# Access Compliance Report

## Public Rights-of-Way

Intersection ID: 27501	Main Street: BRUSH_HOLLOW_RD	Cross Street: BASKING_RIDGE_CT	Location: E
ADA ID: B09DC96F22E7	Ramp Type: Perp	Initial Pass/Fail: Fail	Overall Compliance: No
		Severity Score: 8.75

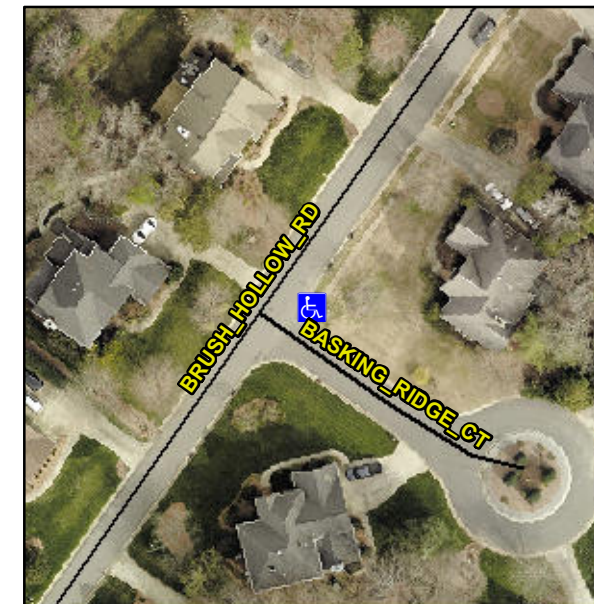
**Not Found, R304.5.1**

Compliance	Description	Data	Compliance	Description	Data
N/A	Ramp Length (in)	46.0	Yes	Ramp Slope (%)	7.8
No	Ramp Width (in)	46.0	Yes	Ramp XSlope (%)	0.2
N/A	Flare Type LT	N/A	N/A	Flare Type RT	N/A
N/A	Flare Slope LT (%)	N/A	N/A	Flare Slope RT (%)	N/A
N/A	Flare Traversable LT?	N/A	N/A	Flare Traversable RT?	N/A
N/A	Landing Length (in)	N/A	N/A	DWS Provided?	N/A
N/A	Landing Width (in)	N/A	N/A	DWS Contrast?	N/A
N/A	Landing Slope (%)	N/A	N/A	DWS Length (in)	N/A
N/A	Landing X Slope (%)	N/A	N/A	DWS Full Width?	N/A
N/A	Landing Curb? (Y/N)	N/A	N/A	DWS Offset (in)	N/A
N/A	Shared Landing?	N/A			
N/A	Gutter Ponding?	N/A	N/A	Gutter Slope (%)	N/A
N/A	Gutter Lip Ht (in)	N/A	N/A	Gutter X Slope (%)	N/A
N/A	Painted X Walk1?	No	N/A	Painted X Walk2?	N/A
	X Walk 1 Direction	To SW		X Walk 2 Direction	N/A
N/A	X Walk 1 Width (in)	N/A	N/A	X Walk 2 Width (in)	N/A
	X Walk 1 Slope (%)	0.7		X Walk 2 Slope (%)	N/A
	X Walk 1 X Slope (%)	0.3		X Walk 2 X Slope (%)	N/A

**Remove & Replace Entire Ramp.**
